C.R. #39

ENVIRONMENTAL ASSESSMENT  
SHORT FORM FOR DETERMINING NONMAJOR ACTION

County, Route, Section Logan-CR 39-4.98 PF LOG017

Type Improvement Replacement of a bridge over an unnamed fork of the Great  
Miami River

SITE PLAN  
 BR No. 39-4.98  
 Richland Townshi  
 Logan County,  
 Over a Branch of the South R  
 Sta 176+32 to Sta 17  
 DESIGNED DRAWN CHECKED REVISE  
 R.A.B. R.A.B.

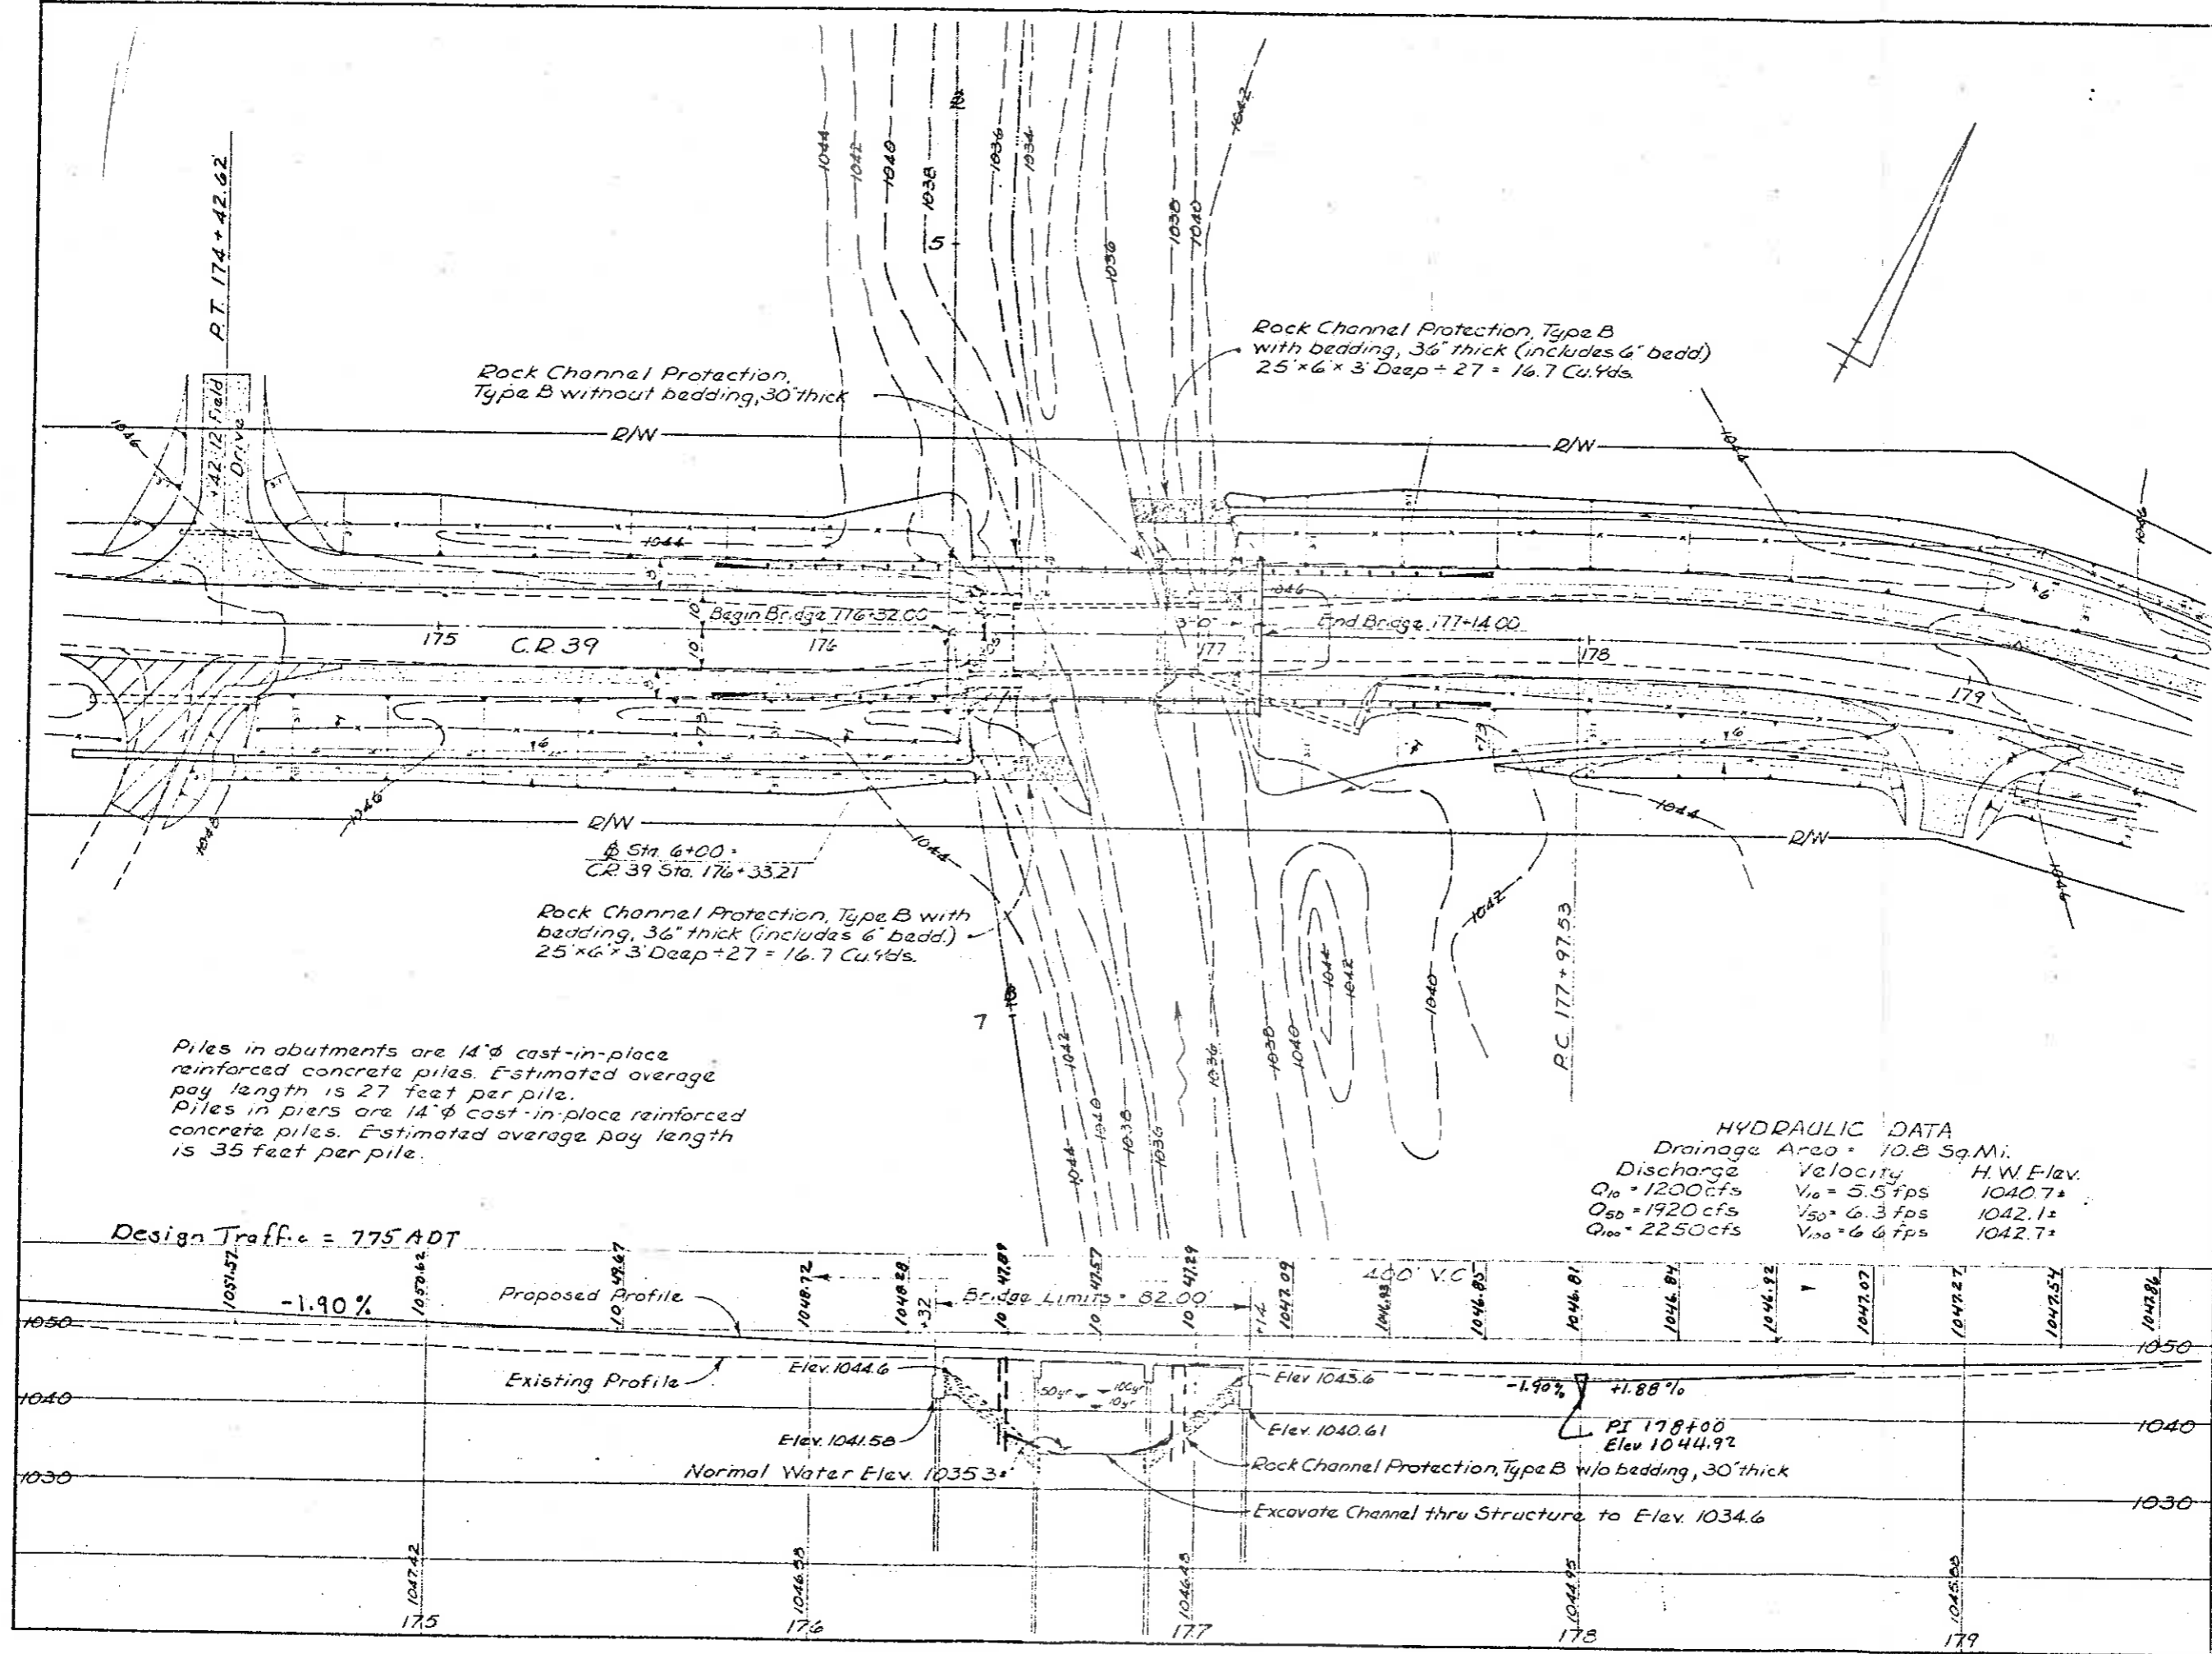
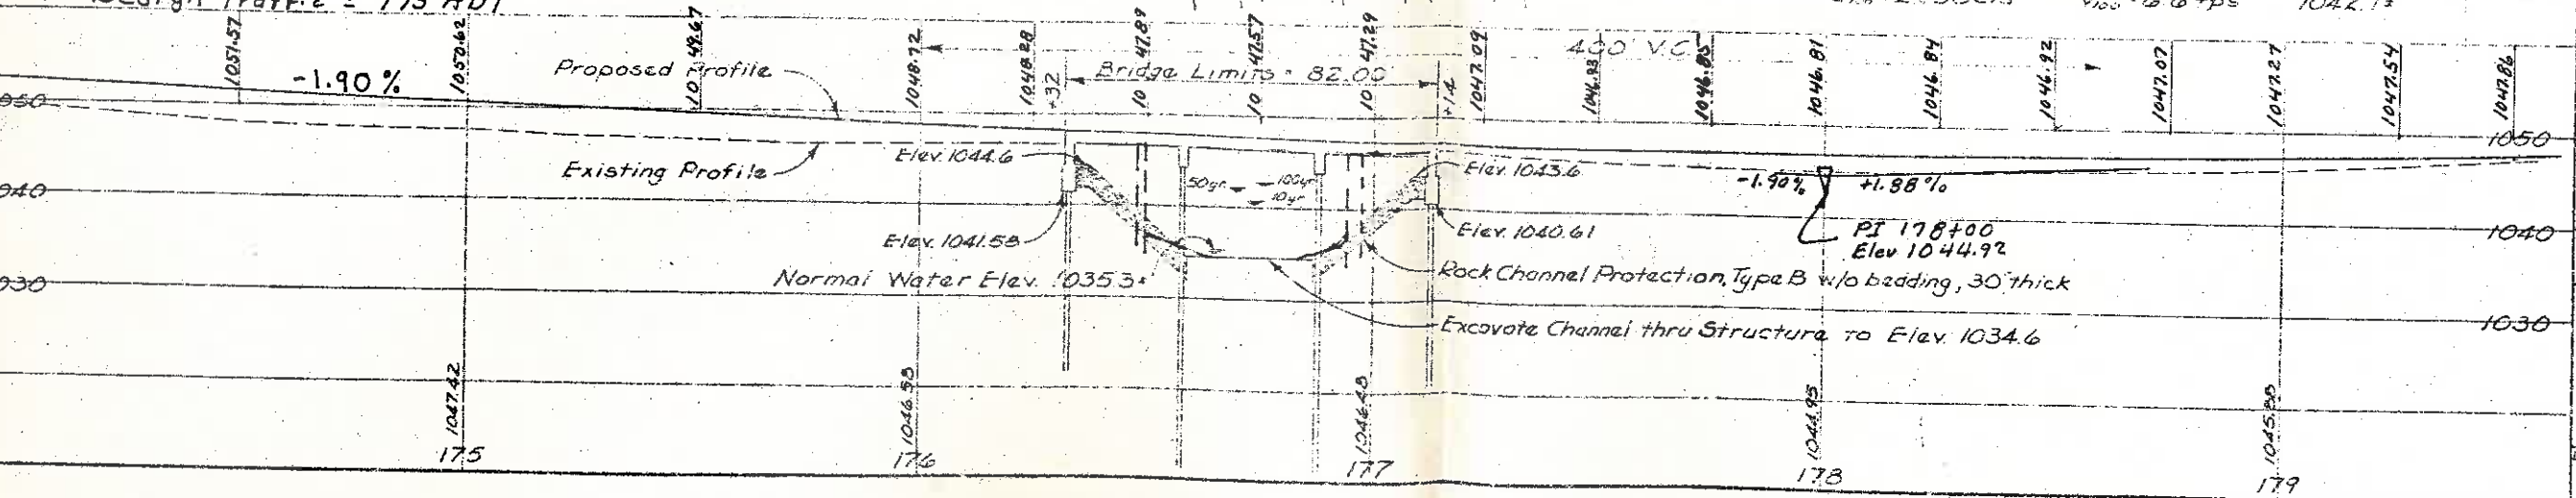
We have reviewed the preliminary site plan for the above named structure and offer the following suggestions:

- ✓ 1. We assume that the County Engineer has determined that this bridge replacement, with respect to waterway opening, is in the public interest based on past flood experience.
- ✓ 2. Calculate clearance to design high water and note on site plan.
- ✓ 3. In upper right hand corner change BR. to CR.
- ✓ 4. Show 2 to 1 slopes in the plan and profile views.
- ✓ 5. Designer, checker and reviewer should initial site plan.
- ✓ 6. Earth work limits note should be on site plan.
7. We suggest using standard drawing CPA-2-73 with 3'3" bench for the abutments.

Re: Log Br. 39-4.98

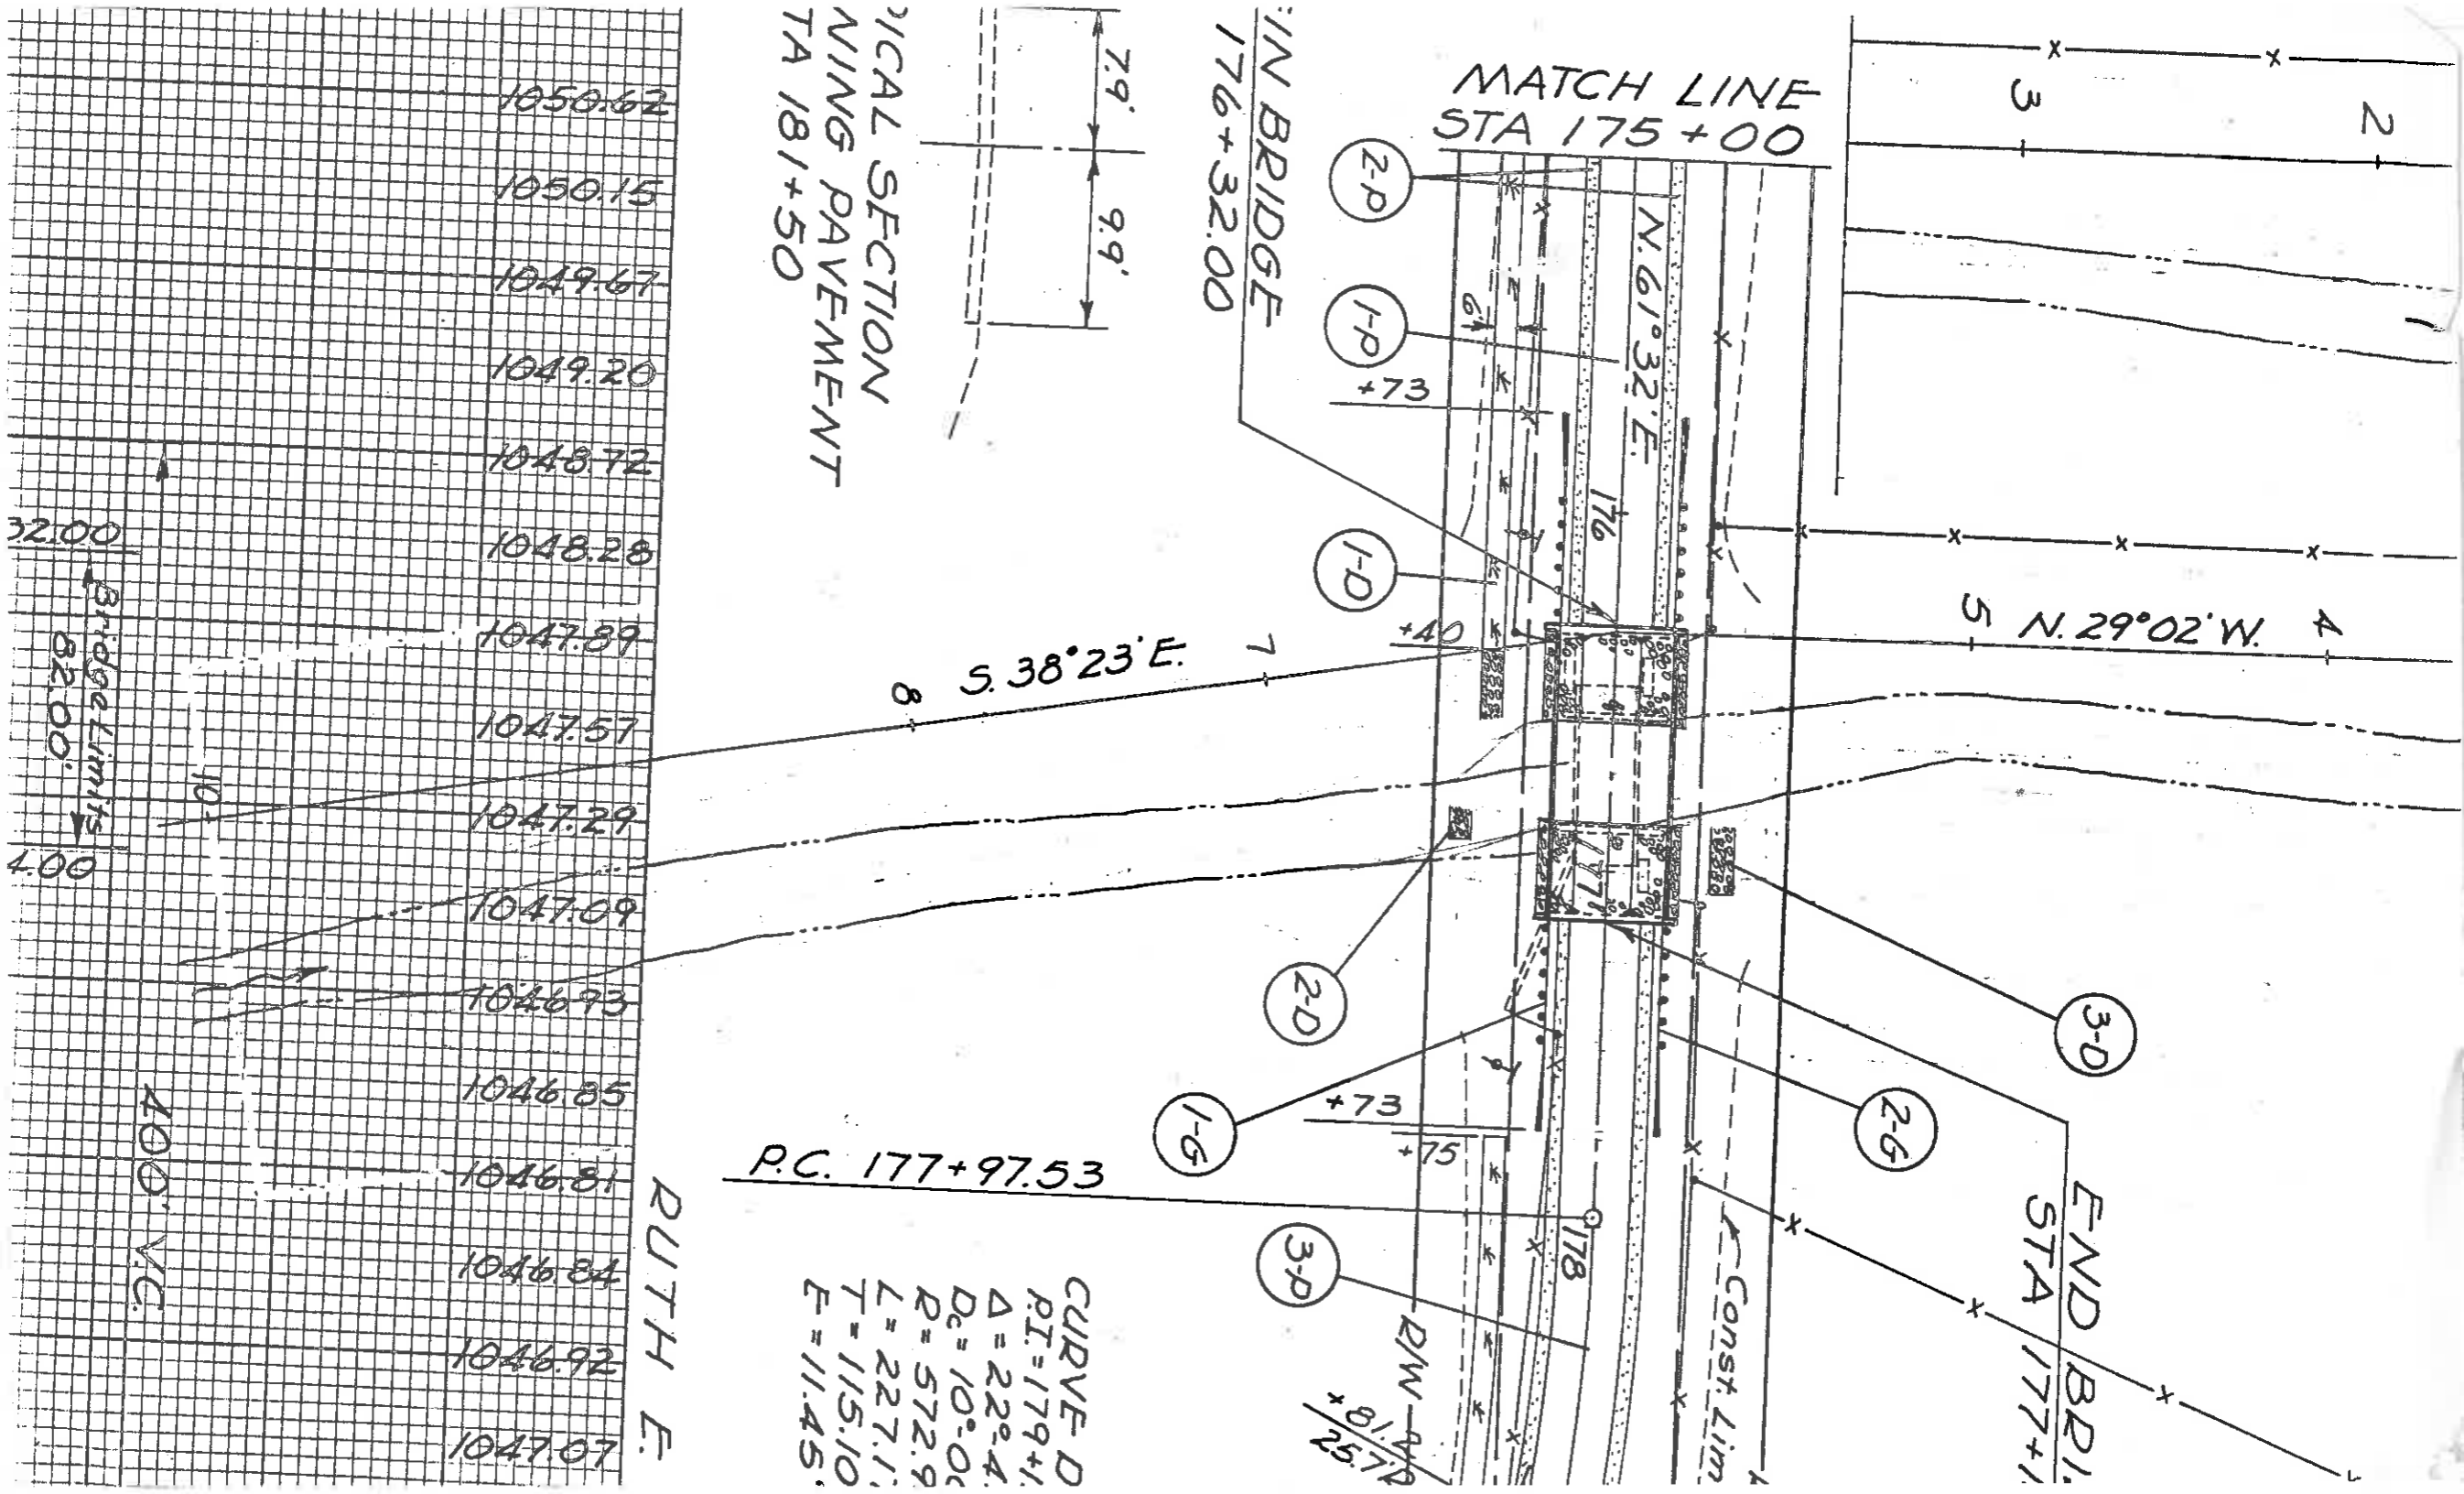
Originally the County Engineer had proposed to do 800± of channel relocation. However, due to the environmental problems he has decided to reduce the amount of channel work to that shown on the attached site plan. The work now proposed is within the right of way and involves only the minor shaping needed to place the Rock Channel Protection.

Due to environmental considerations we have decided to reduce the amount of channel work on the above referenced bridge replacement project. Please find enclosed a print of the revised site plan showing the proposed channel work, which is now contained within the proposed right-of-way.
